Addendum No. 005

BID No. 08MOT26, Demolition, LHS-Imperial site, (No DSA) Campus Renovations

ADDENDUM 005 B – Bldgs. A, D, F, H, I Demolition

PROJECT
LUSD – Lynwood High School Demolition Package

AA-1.01

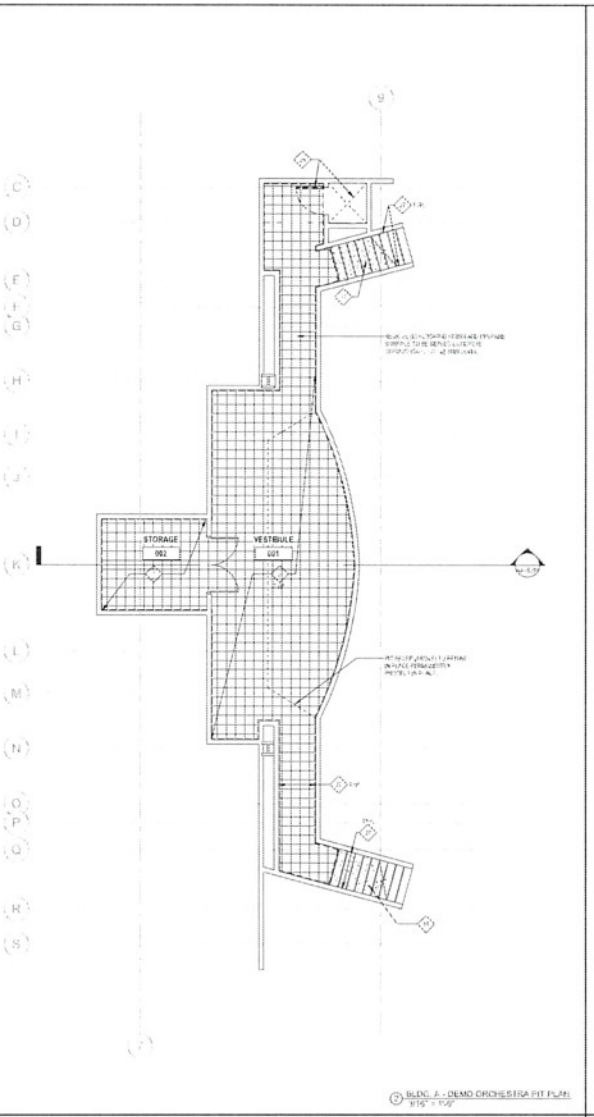
Discipline	Sheet	Description	Reason for Change
General	T-2	Sheet index updated. Removed theatrical drawings from scope. Added Electrical sheet EA-2.2.	Technical coordination
Architectural	AA-1.01	Revised keynotes, added new keynotes, added new text notes, updated general notes and legends. Added or revised demolition scope.	Technical coordination
	AA-1.02	Revised keynotes, added new keynotes, added new text notes, updated general notes and legends. Added or revised demolition scope.	Technical coordination
	AA-2.01	Revised keynotes, added new keynotes, added new text notes, updated general notes and legends. Added or revised demolition scope.	Technical coordination
	AA-5.01	Revised keynotes, added new keynotes, added new text notes, updated general notes and legends. Added or revised demolition scope.	Technical coordination
	AD-1.01	Removed exterior demolition work from scope.	Technical coordination

drawing no:
AD-1.01

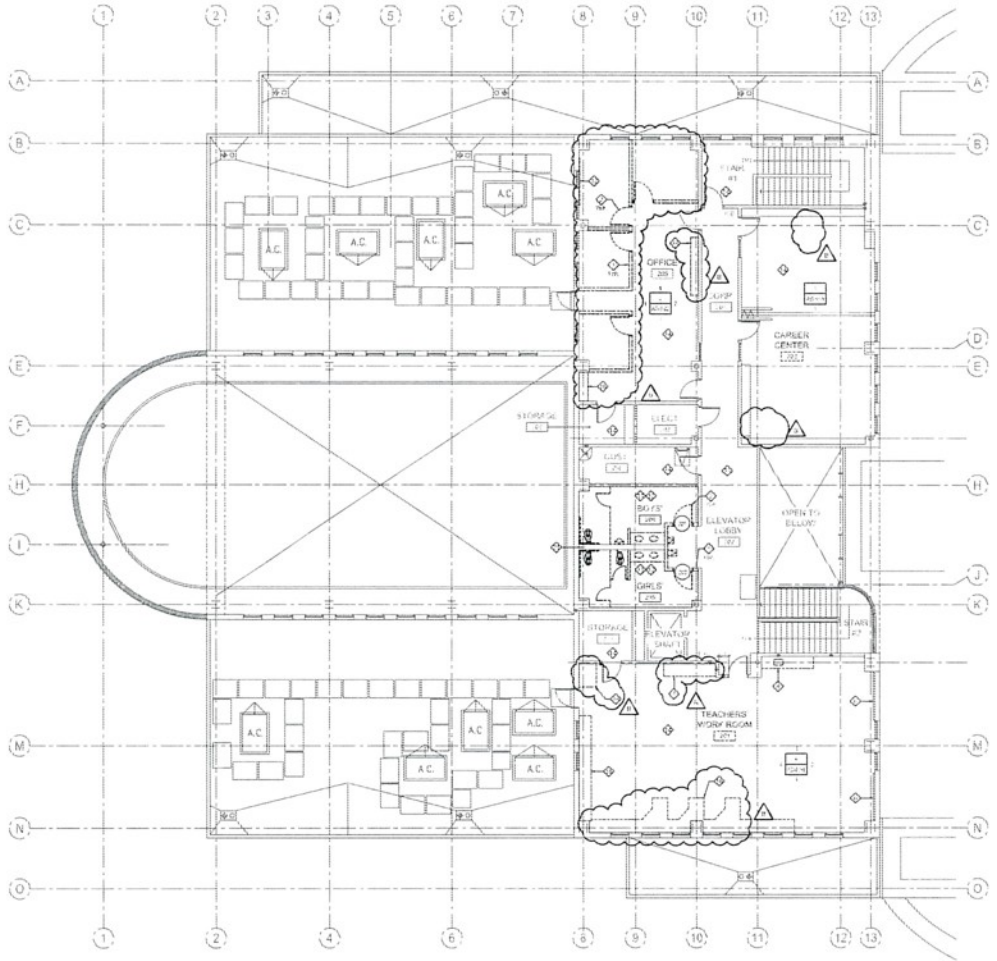
Furniture added to plan with associated keynotes.	
		Added sink to be removed in Room 102.	
		General Notes revised for clarity.	
		Keynotes added for removal of window blinds, room signage, and wall graphics.	
	AD-1.02	Demolition of existing office space walls and doors.	Technical coordination

drawing no:
AD-1.02

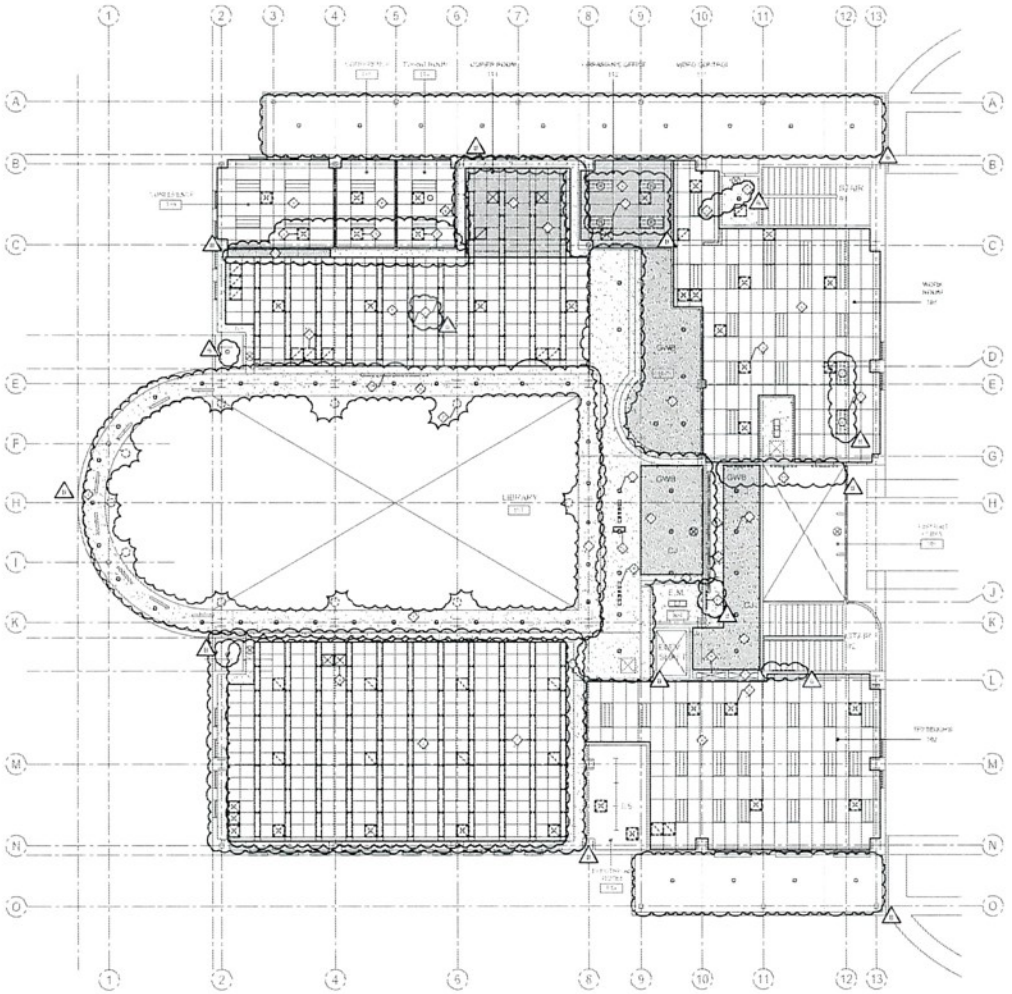
Demolition of existing casework.	
		Keynotes added for removal of signage, graphics, shelving, flooring at stairs, wall tile and panels.	
		General Notes revised for clarity.	
		Keynote to remove plastic laminate from casework deleted and removed from scope.	
	AD-2.01	Reduced scope of gypsum ceiling removal.	Technical coordination
		Removed exterior lighting demolition from scope.	
		Keynotes added to remove art display cases and patch and repair existing gypsum board ceiling.	
		General Notes revised for clarity.	
	AD-202	Reduced scope of gypsum ceiling removal.	Technical coordination
		Keynotes added to remove art display cases and patch and repair existing gypsum board ceiling.	
		General Notes revised for clarity.	
		Reduced scope of gypsum ceiling removal.	
	AD-8.01	General Notes revised for clarity.	Technical coordination
		Keynotes added to remove existing white boards, clock shelving, informational signage, wall base and tile

drawing no
AH-1.0

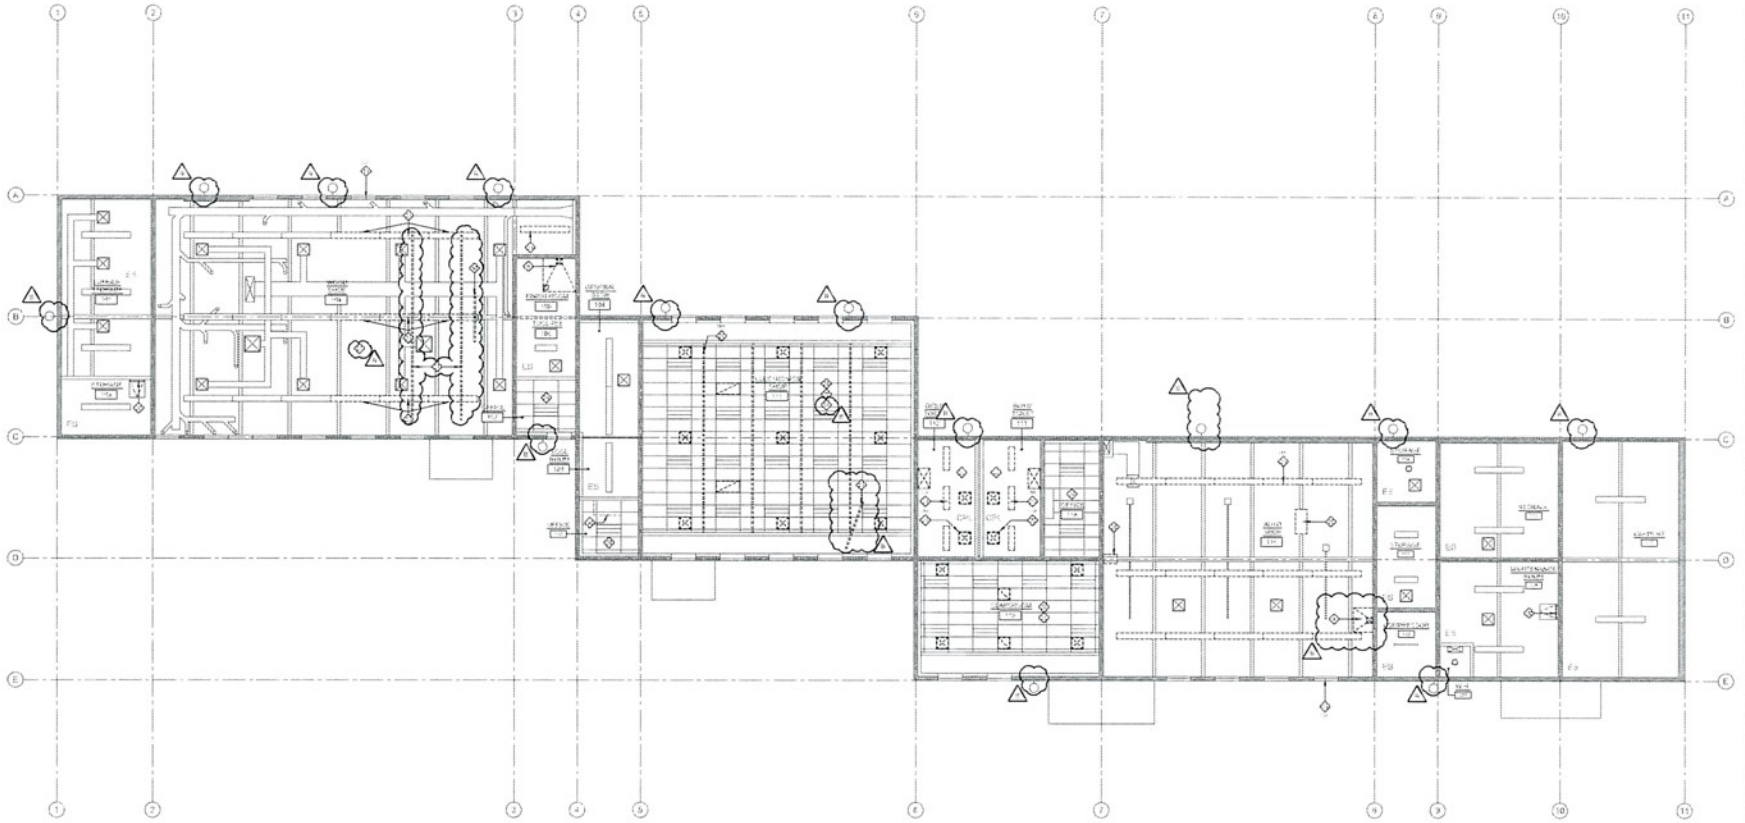
AF-8.02	General Notes revised for clarity.	Technical coordination
		Keynotes added to remove column wrap covers and coiling door.	
		Dimensions removed from elevation.	
		Keynote 21 to remove plastic laminate from casework deleted.	
		Transaction window scope removed.	
	AF-8.03	General Notes revised for clarity.	Technical coordination
		Keynotes added to remove column wrap covers and coiling door.	
		Dimensions removed from elevation.	
		Keynote 21 to remove plastic laminate from casework deleted.	
		Transaction window scope removed.	
		Added interior column footing detail.	
	AH-1.0	General Notes revised for clarity.	Technical coordination

Existing keynotes revised for clarity.	
		Removed exterior demolition work from scope.	
		Remove interior hallow metal door demolition work from scope.	
		Remove new interior door opening from scope.	
		Remove marker board demolition in Electronic shop 111.	
		Remove one marker board demolition in Classroom 115 from scope, only one panel will be removed from the other marker board.	
		Remove existing trench removal in Autoshop 116 from scope.	
		Added scope: remove the existing eyewash station, sink, and shower in Woodshop 104.	
		Added scope: remove the existing lift in Carport 121.	
		Keynote #1, removed floor prep note.	
		Keynote #9, added note to protect existing housekeeping pad.	
		Keynote #15, added note to return fire extinguisher cabinet to district.	
		Keynote #36, added note to remove hydraulic fluids.	
	AH-2.0	General Notes revised for clarity.	Technical coordination
		Existing keynotes revised for clarity.

Remove exterior wall pack demolition work from scope.	
		Added scope: remove existing raceway in Woodshop 104.	
		Added scope: remove existing pull down screen in Woodshop 104 and Electronics shop 111.	
		Added keynote to indicate the removal of existing hood in Autoshop 116.	
		Keynote #6, added note to remove ductwork.	
		Keynote #22, added note to protect all existing devices installed in ceiling.	
		Keynote #51, added note to protect existing pressurized air system in Woodshop 104 and Electronics shop 111.	
	AH-4.0	General Notes revised for clarity.	Technical coordination
		Existing keynotes revised for clarity.	
		Removed exterior demolition work from scope.	
		Remove exterior wall pack demolition work from scope.	
		Keynote #4, added note to protect existing housekeeping pad.

drawing no:
MA-2.0

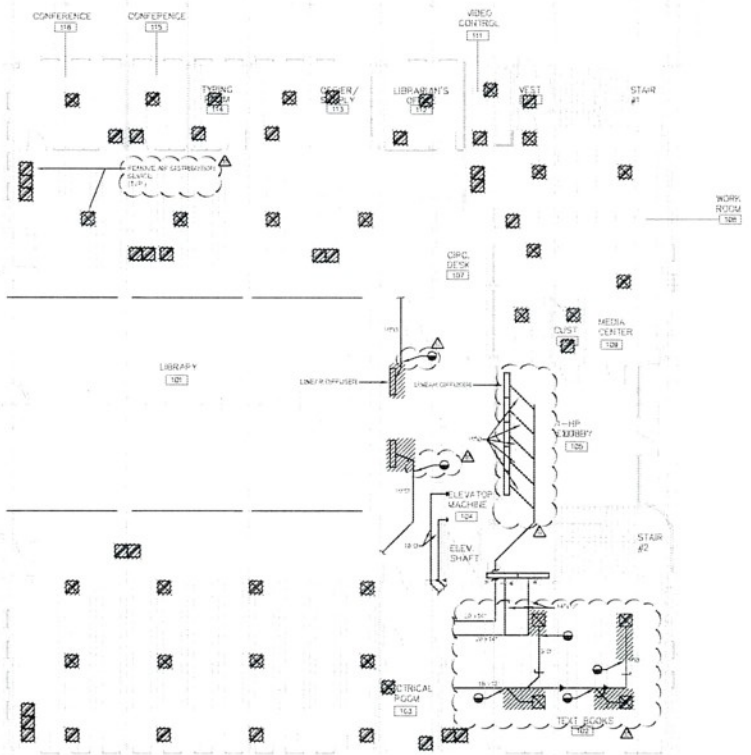
Added scope: remove existing fly fans above doors in Faculty Dining 105.	
Mechanical	MA-2.0	1. Revised note for removal of air distribution device. 2. Removed portions of duct being hatched.	Technical coordination
	MD-2.0	1. Revised note for removal of air distribution device. 2. Removed demo hatch for linear diffusers and duct at the Exit Lobby 105. 3. Revised demo hatch at Textbooks 102. 4. Indicated point of demolition.	Technical coordination
	MD-2.1	1. Revised note for removal of air distribution device. 2. Revised demo layout near Office 205. 3. Removed demo hatch for portions of duct and linear diffusers at Elevator Lobby 202 and Corridor 204	Technical coordination
	MF-2.0	1. Revised note for removal of air distribution device 2. Extended portions of duct being demolished at Women's Toilet 127 3. Added missing grilles to be demolished at storage 107. 4. Removed demo scope at Toilet 109 and 126.	Technical coordination

drawing no:
MH-2.1
drawing of 1

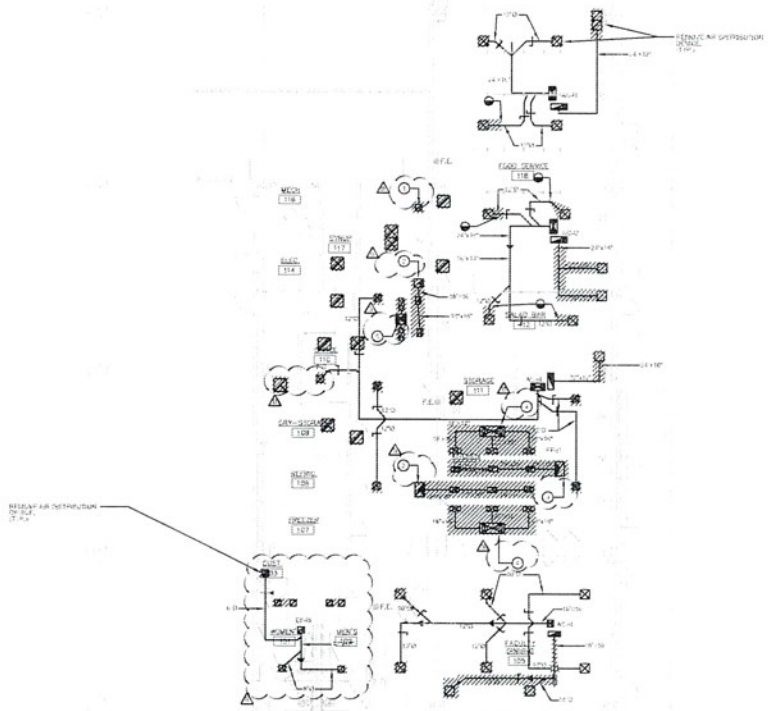
MH-2.1	1. Revised note for removal of air distribution device. 2. Removed demo hatch for duct at Boy's Toilet 113 and Girl's Toilet 112. 3. Added missing grille to be demolished at Tool Room 106. 4. Added sheet notes. 5. Added demo hatch for duct riser in Storage 117. 6. Removed EF-H14 demo scope in Storage 117	Technical coordination
	MI-2.1	1. Revised note for removal of air distribution device. 2. Removed demo hatch for duct at Women's 101 and Men's 102. 3. Added missing grille to be demolished at Dry Storage 109. 4. Added demo hatch for supply grille at Office 110. 5. Added sheet notes.	Technical coordination

drawing no:
PA-2.0

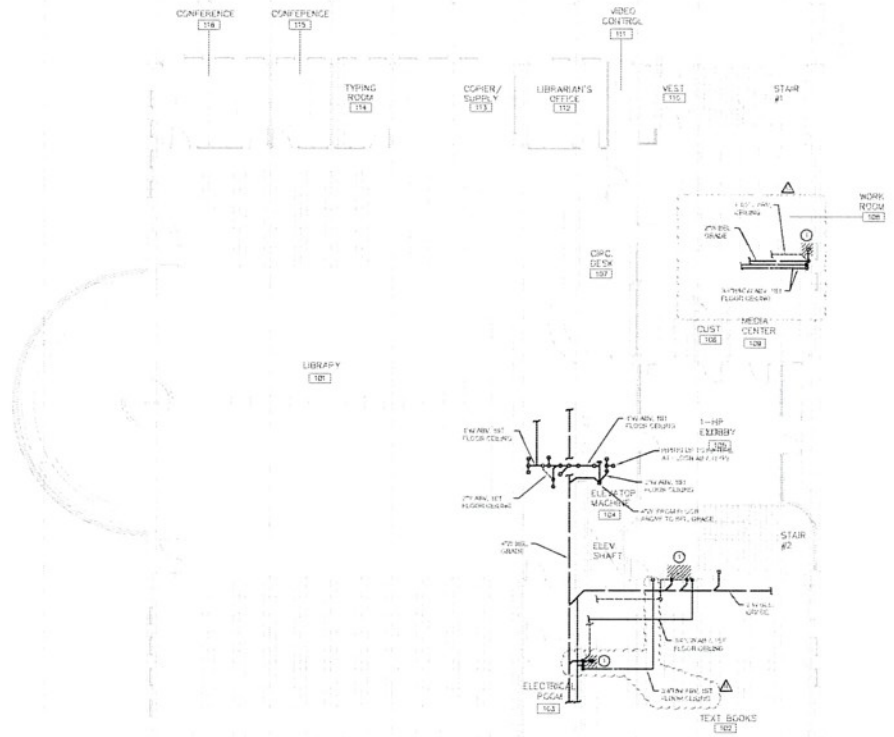
Plumbing	P-0.1	1. Revised sheet index. 2. Added compressed air piping to Plumbing Symbols.	Technical coordination
	PA-2.0	1. Added demolition work scope and existing utility piping layout to Corridor 116 and Dressing Rooms 123 & 119. 2. Added demolition work scope and existing utility piping layout to Men's RR 143 and Women's RR 140. 3. Revised sheet notes.	Technical coordination
	PD-2.0	1. Added demolition work scope and existing utility piping layout in Work Room 108. 2. Added demolition work scope and existing utility piping layout in Text Book Room 102. 3. Revised sheet notes.	Technical coordination
	PD-2.1	1. Added demolition work scope and existing utility piping layout in Teacher's Work Room 201. 2. Revised sheet notes.	Technical coordination
	PF-2.0	1. Added demolition work scope and existing utility piping layout in Break Room 105A. 2. Added demolition work scope and existing utility piping layout in Waiting Room 144. 3. Removed demolition work scope in Toilet Room 109. 4. Removed demolition work scope in Toilet Room 126. 5. Revised sheet numbering 6. Revised sheet notes.	Technical coordination

drawing no.
PH-2.0
drawing of ?

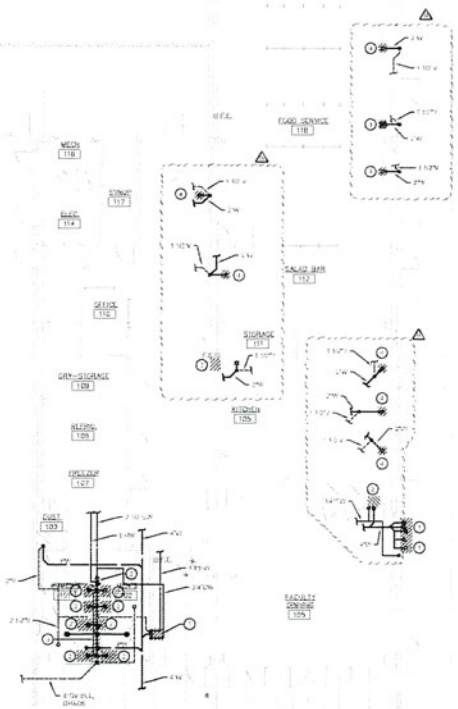
PH-2.0	1. Added compressed air piping layout throughout the building. 2. Added demolition works scope and existing utility piping layout in Wood Shop room 104. 3. Revised sheet notes.	Technical coordination
	PI-2.0	1. Added demolition work scope and existing utility piping layout in the Kitchen 105, Food Service 118 and Salad Bar 112 areas. 2. Revised sheet notes.	Technical coordination
Electrical	E-0.1	1. Adjusted the sheet index.	Technical coordination

drawing no.
EA-2.1

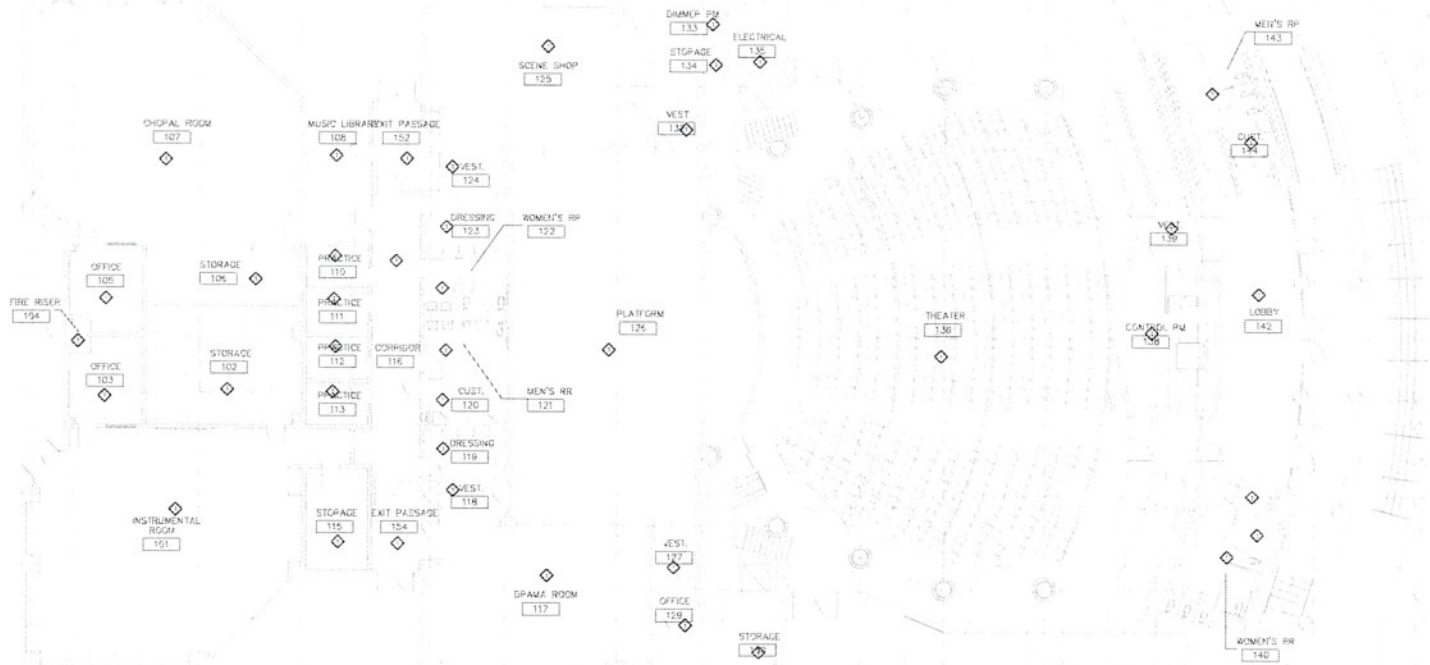
EA-2.1	1. Revised type of switches in rooms. 2. Removed fixture tags. 3. Provided lighting circuit information. 4. Provided sheet note call outs on plan.	Technical coordination
	EA-2.2	1. New sheet.	Technical coordination
	ED-2.1	1. Revised type of switches in rooms. 2. Removed fixture tags. 3. Provided lighting circuit information. 4. Provided sheet note call outs on plan.	Technical coordination
	ED-2.2	1. Revised type of switches in rooms. 2. Removed fixture tags. 3. Provided lighting circuit information. 4. Provided sheet note call outs on plan.	Technical coordination
	ED-2.3	1. Provided power circuit information. 2. Provided sheet note call outs on plan.	Technical coordination
	ED-2.4	1. Provided power circuit information. 2. Provided sheet note call outs on plan.	Technical coordination
	EF-2.1	1. Revised type of switches in rooms. 2. Removed fixture tags. 3. Provided lighting circuit information. 4. Provided sheet note call outs on plan.	Technical coordination

drawing no.:
EF-2.2

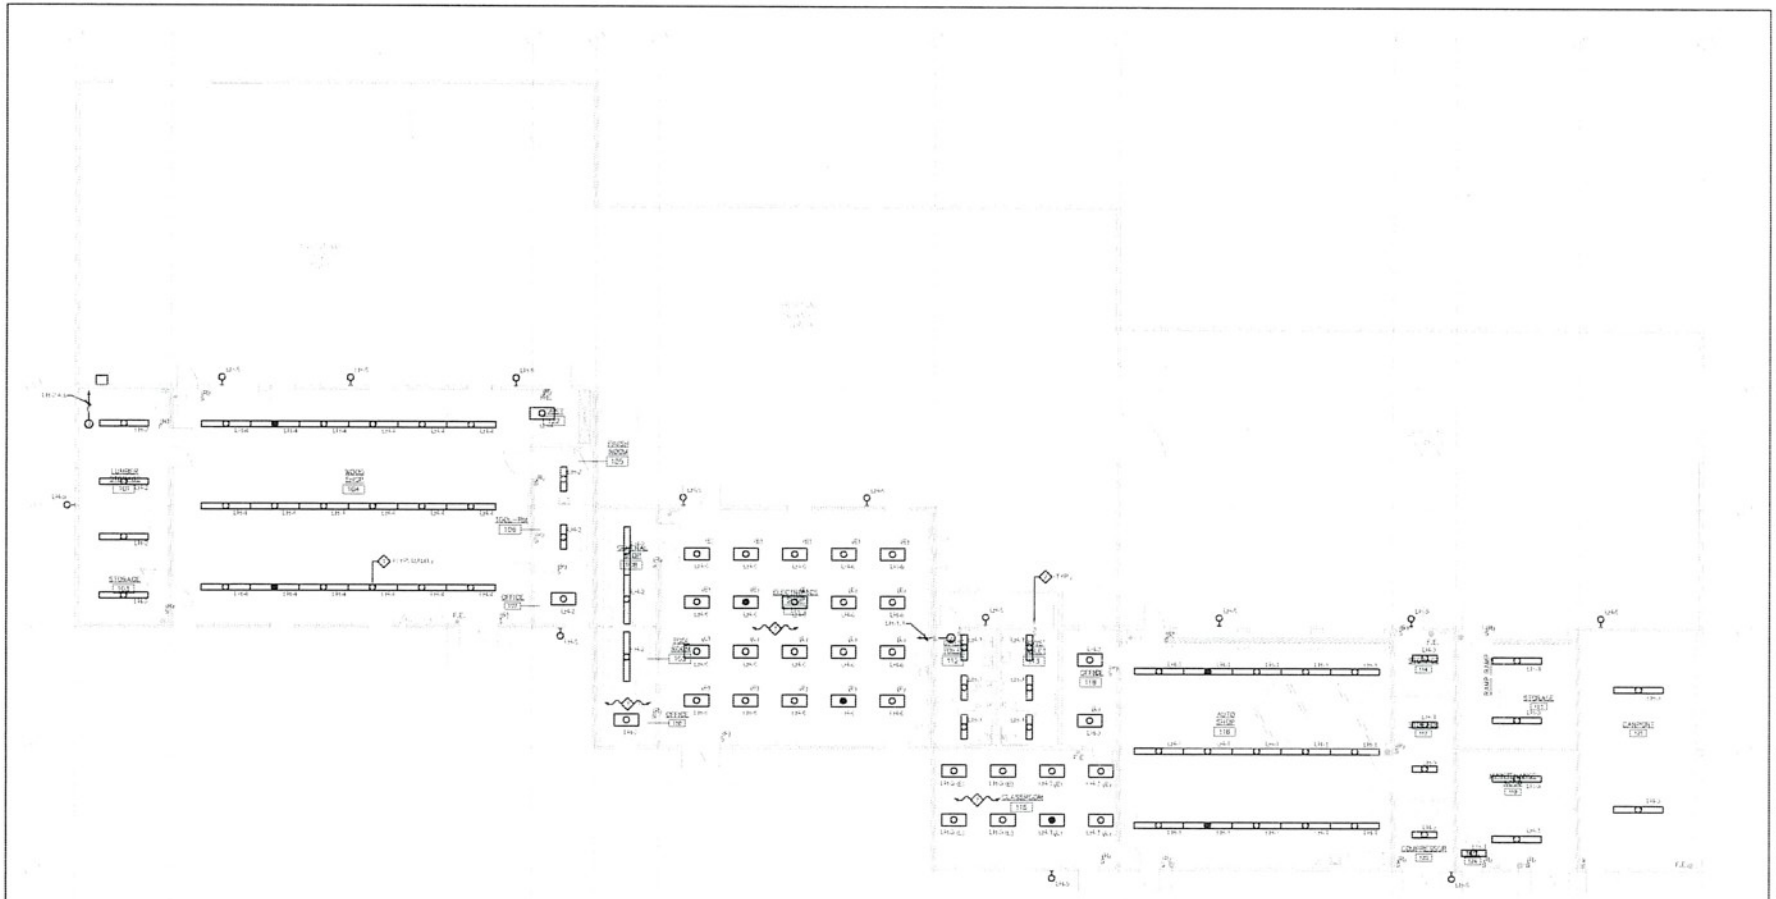
EF-2.2	1. Provided power circuit information. 2. Provided sheet note call outs on plan.	Technical coordination
	EH-2.1	1. Revised type of switches in rooms. 2. Removed fixture tags. 3. Provided lighting circuit information. 4. Provided sheet note call outs on plan.	Technical coordination
	EH-2.2	1. Provided power circuit information. 2. Provided sheet note call outs on plan.	Technical coordination
	EI-2.1	1. Revised type of switches in rooms. 2. Removed fixture tags. 3. Provided lighting circuit information. 4. Provided sheet note call outs on plan.	Technical coordination
	EI-2.2	1. Provided power circuit information. 2. Provided sheet note call outs on plan.	Technical coordination
